NRC – Callaway / Wolf Creek Public Meeting

GL 2004-02 Response RAIs
November 20
2009

- The purpose of this presentation is to address GL 2004-02 RAIs for Union Electric Company (Callaway) and Wolf Creek Nuclear Operating Corporation (Wolf Creek).

Figure 26-1

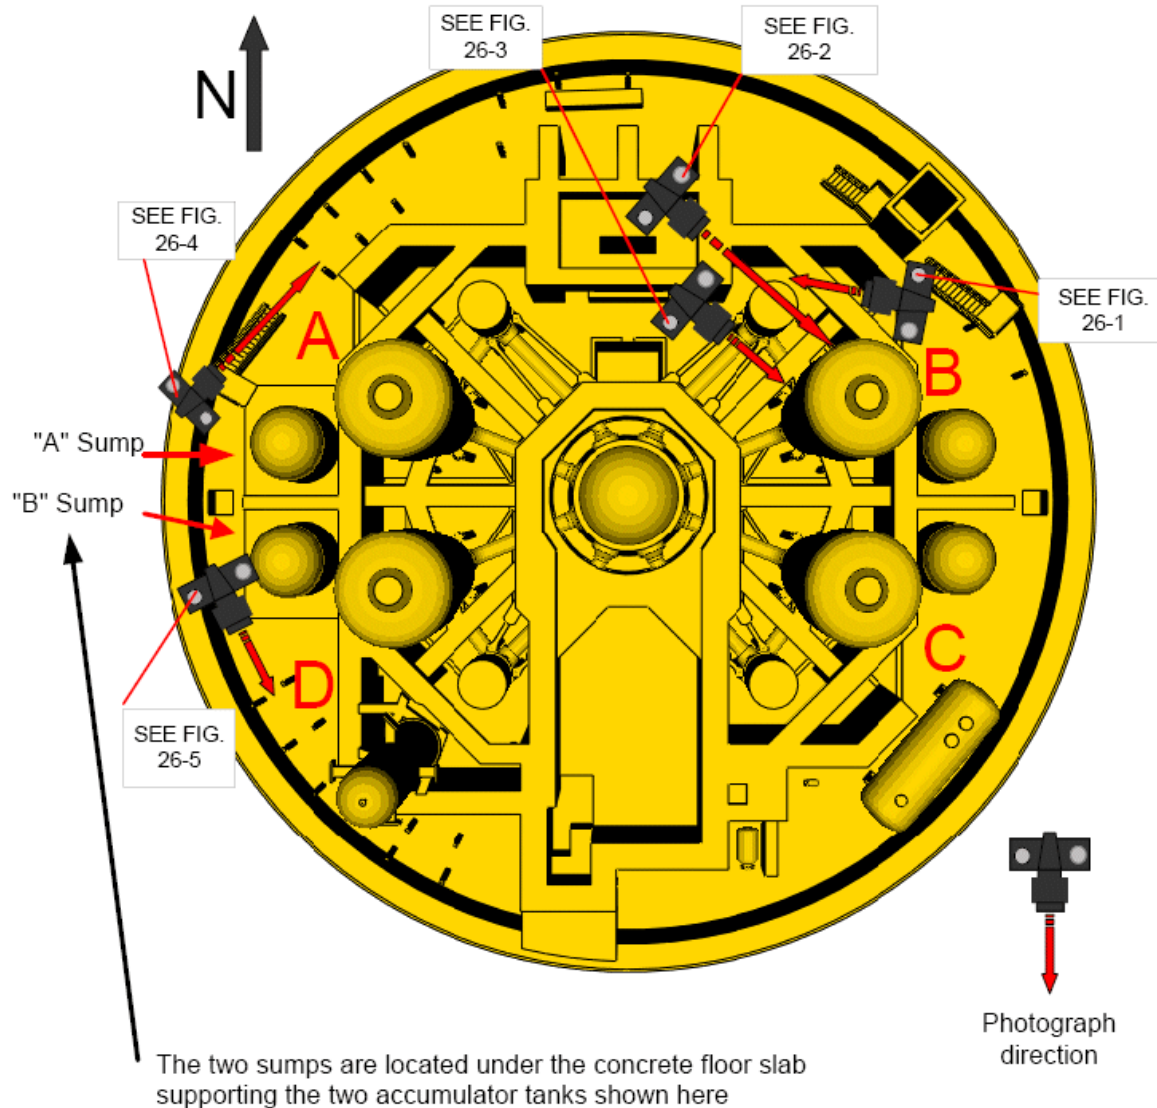
- Of all of the miscellaneous debris tested, only two materials were found capable of floating.
 - These two materials represent 1.4% of all miscellaneous debris assumed.
 - The maximum surface area of miscellaneous debris postulated to float is only 4.6 ft² total if all debris generated that floats reaches the screen. Applying the 75% area reduction criteria for equipment labels and tape (SE, “Staff evaluation of GR Section 3.5.2.2.2”); only 3.45 ft² is postulated to float to the top of screens.
 - 3.45 ft² represents 0.1% of one strainer assembly surface area; which is not significant when compared to the total area available
 - All other miscellaneous debris (~98%) was found to not float.

- 95% of the miscellaneous debris (313.8 ft² of 330.2 ft²), all non-porous is initially located inside the secondary shield wall, would be subjected to pipe break conditions (100% humidity)
- Pre-soaking the debris is prototypical since the miscellaneous debris will be wetted (surface air bubbles removed) by direct exposure to the LOCA break and long transport time due to tortuous path to the strainers

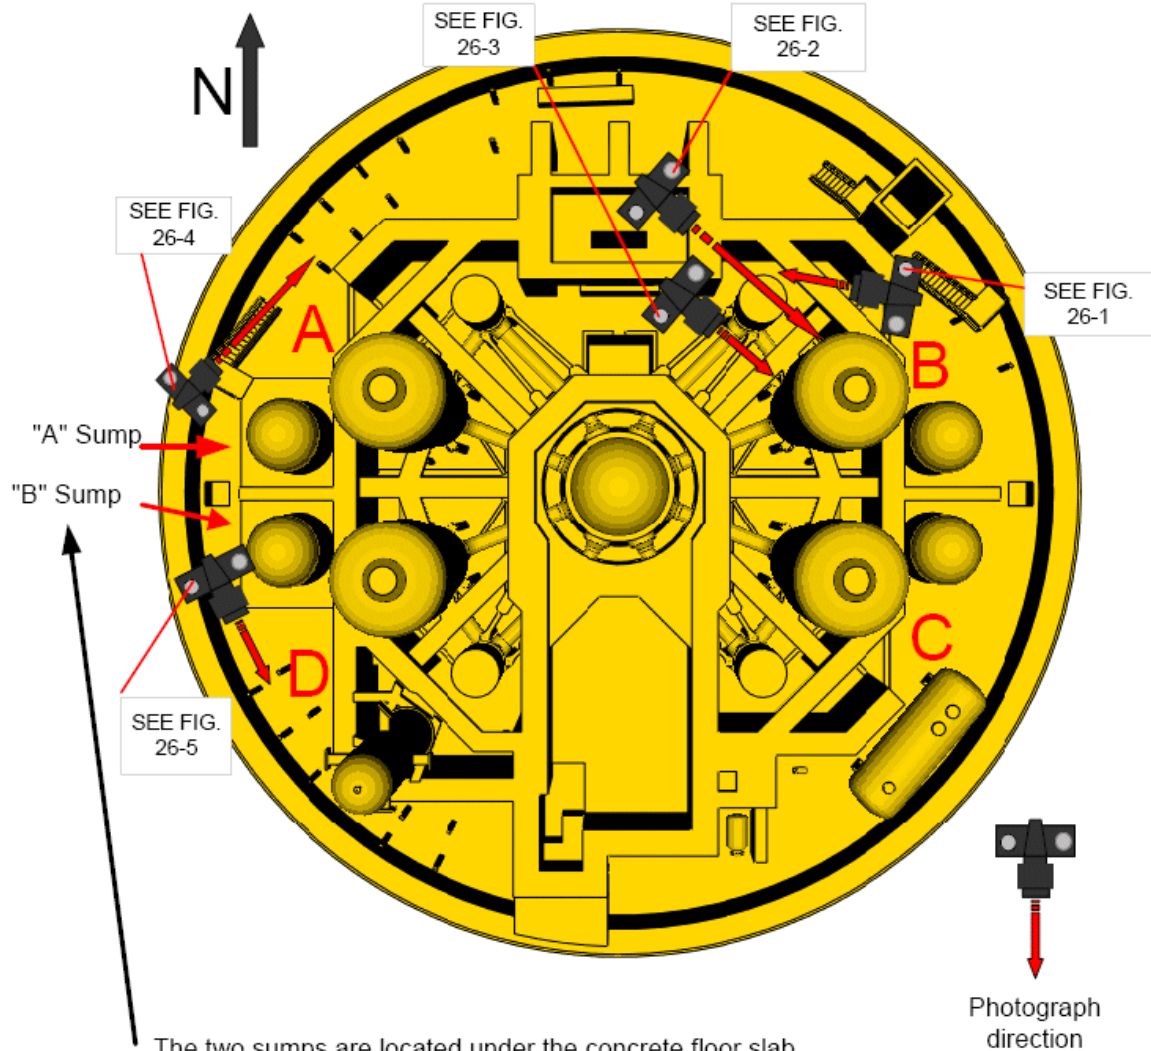
- There are numerous obstructions within the bioshield and the containment annulus that would serve to capture large debris during pool-fill phase of a LOCA.
 - Refer to RAI #26

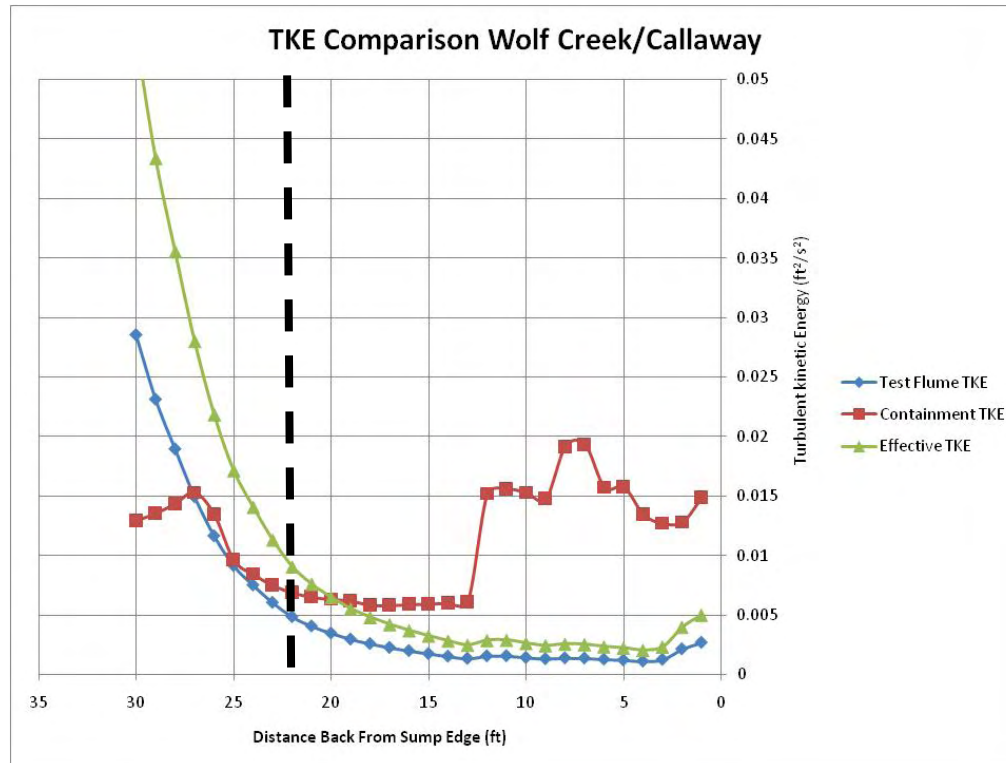
- Effective turbulence level takes into account the differential in flume and containment water temperatures and is a correction of the flume TKE to containment temperatures.
- ***Higher turbulence predicted by the debris transport containment CFD simulations within 20 ft of the sump pit did not affect the flume test results since no debris deposition was observed in the test flume within 23 ft of the test strainer modules.***

Figure 9. Smalls fiber addition

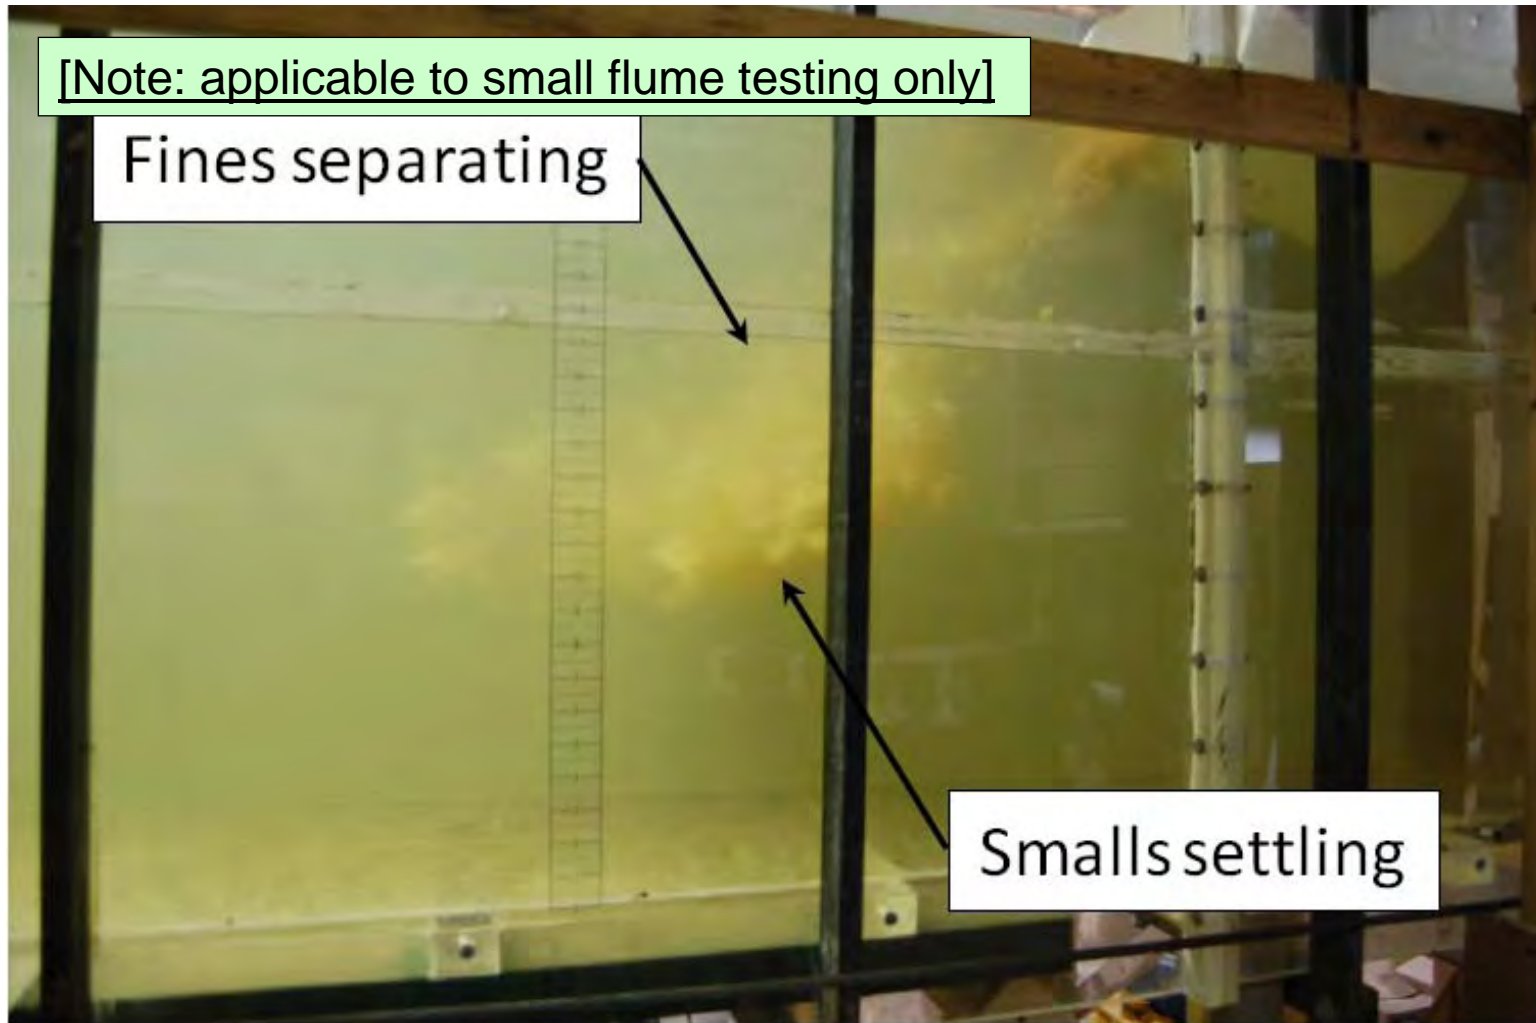
- Small flume testing was conducted
 - Video documentation and test descriptions were submitted to the Staff on November 4, 2009
 - Velocity during the small flume test was equal to the minimum velocity sections of the large flume strainer head loss testing
- The video of the small flume test has confirmed separation of the fine fibrous debris upon introduction of small fines mixture did occur in a manner that did not affect transport to the strainers

Callaway Refined CFD Model Configuration

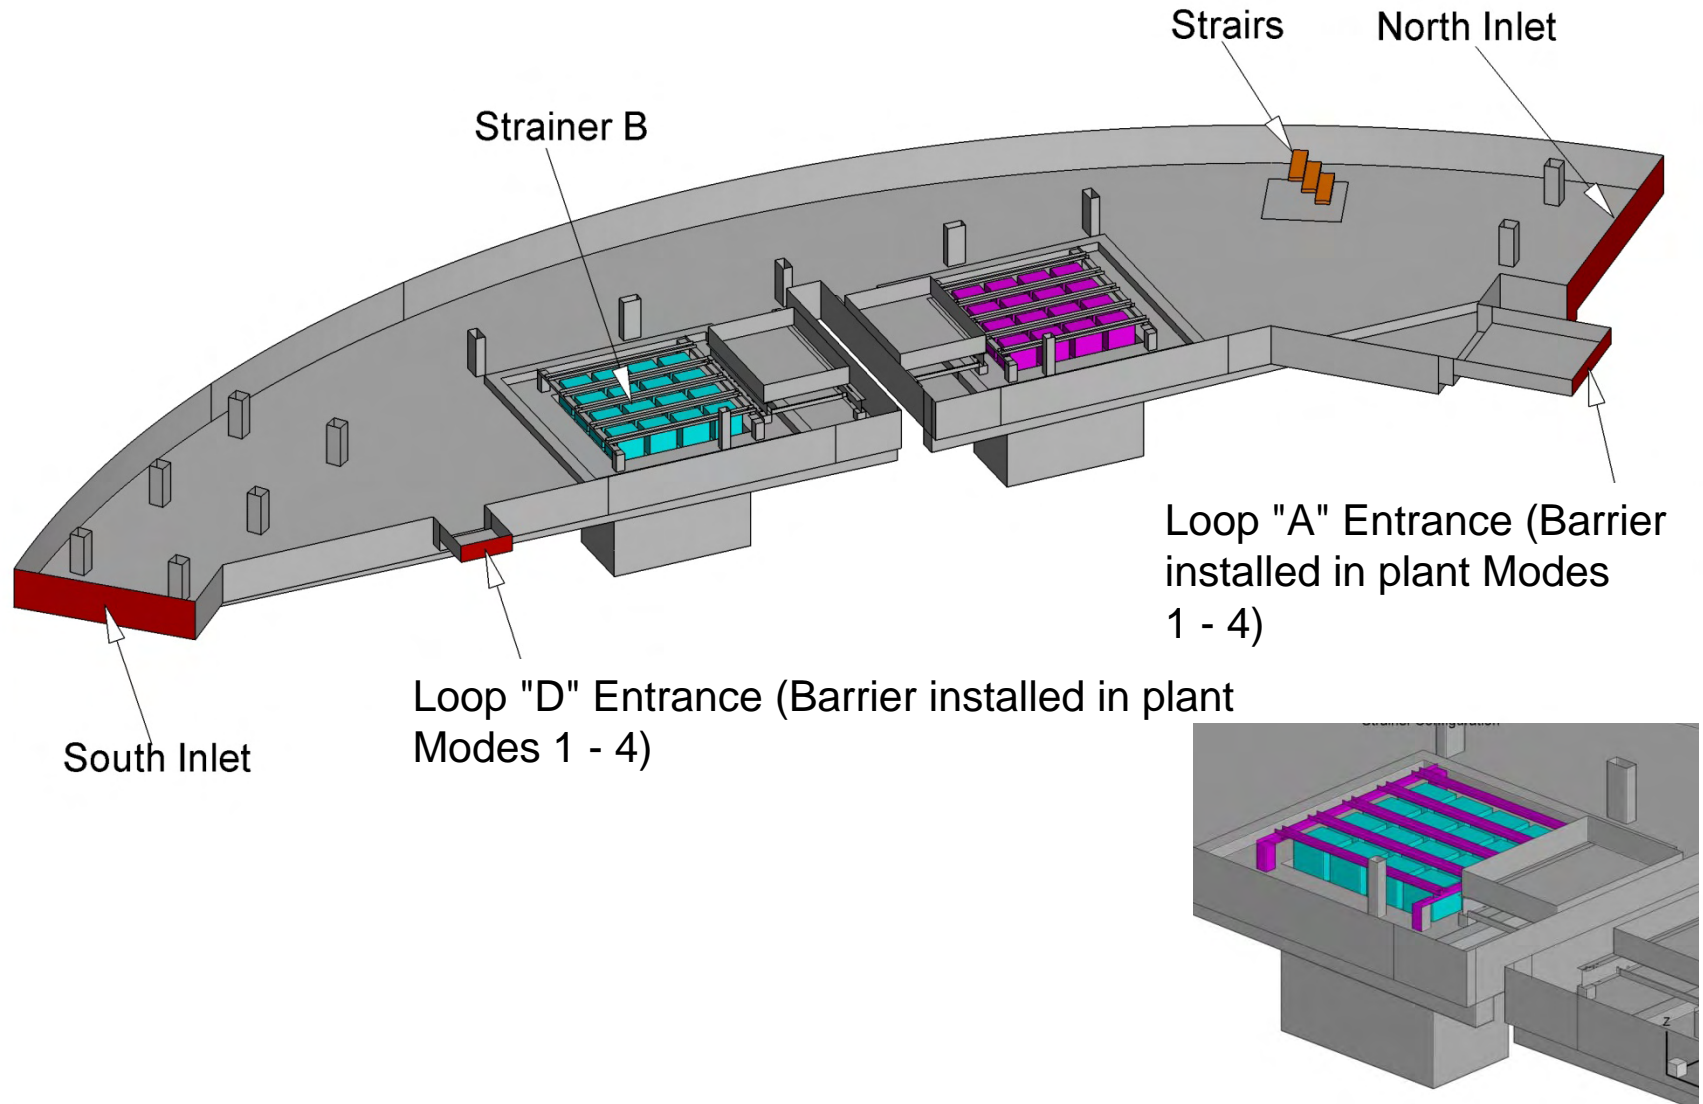
- Subsequent CFD simulation results showed sensitivity of flow patterns to obstacles near sump pit and complex flow patterns within the sump strainer array.
 - Velocities within 8 ft of Callaway sump and 13 ft of Wolf Creek sump higher than test flume CFD due to angular velocity component in flow.
 - Design basis test photos and observations for both Wolf Creek and Callaway noted no settling of debris within 23 ft of the test strainer modules.
 - Fiber-only test photos (with clear visibility in the test flume) also noted no appreciable settling within 23 ft of test strainer modules.
 - Note that test flume velocities within 23 ft were three times higher than the incipient tumbling velocity for small fiberglass (0.06 ft/s) and twice that for large fiberglass (0.12 ft/s).

Approach Velocity Calculation with TSP Basket and Instrument Support

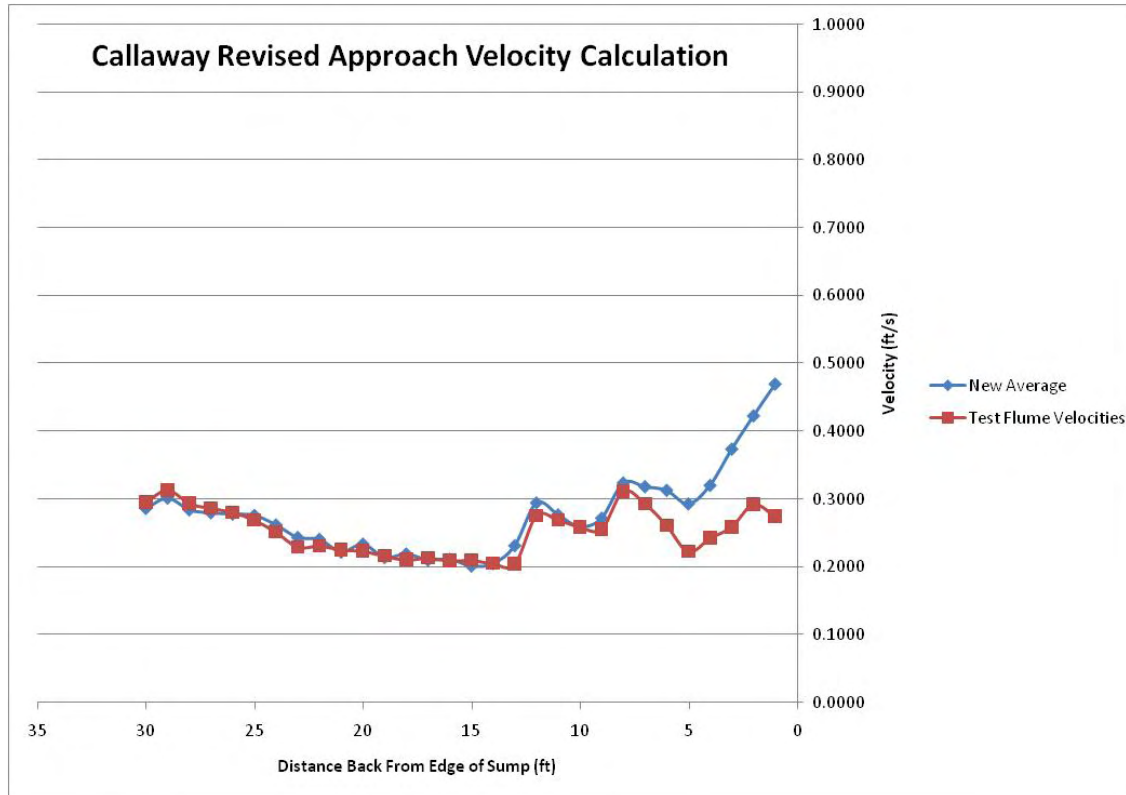
- Velocities in Drop Zone and up to 14 ft back from sump equivalent
- Velocities from 8 ft to 14 ft very similar
- Velocities from 1 ft to 8 ft higher based on refined CFD

Approach Velocity Calculation with Instrument Support

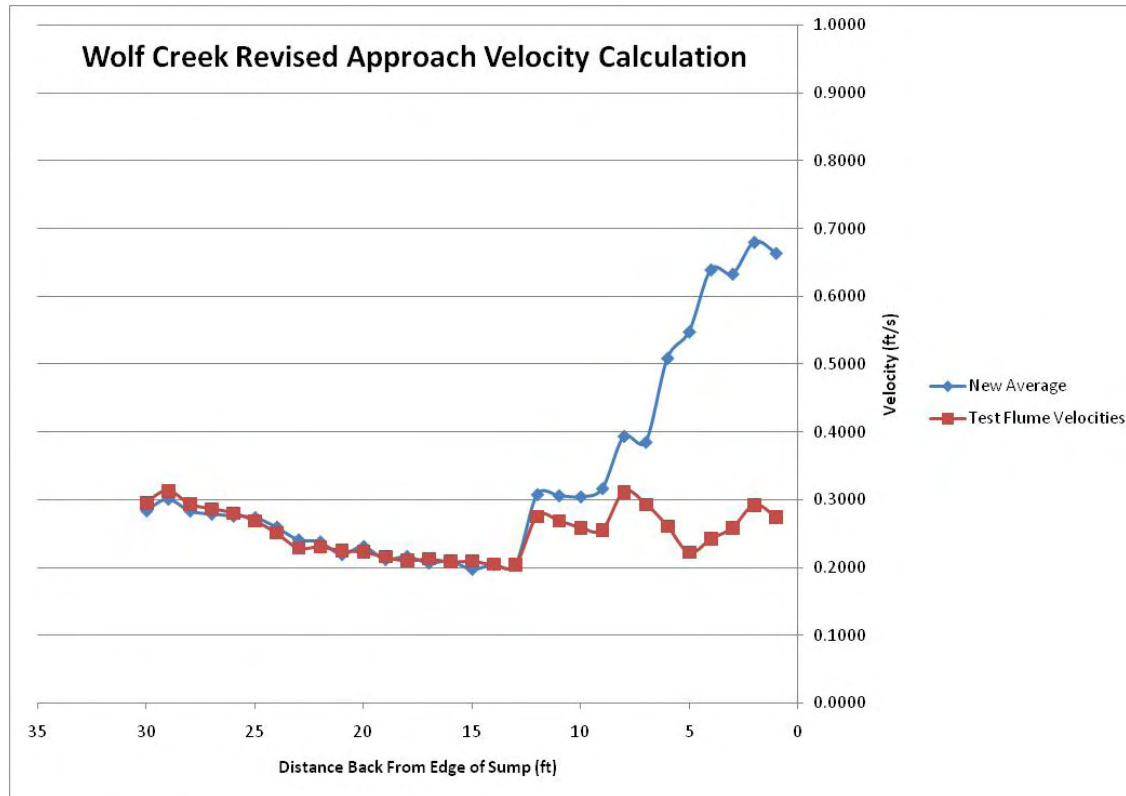
- Velocities in Drop Zone and up to 13 ft back from sump equivalent
- Velocities from 1 ft to 13 ft higher based on recent CFD
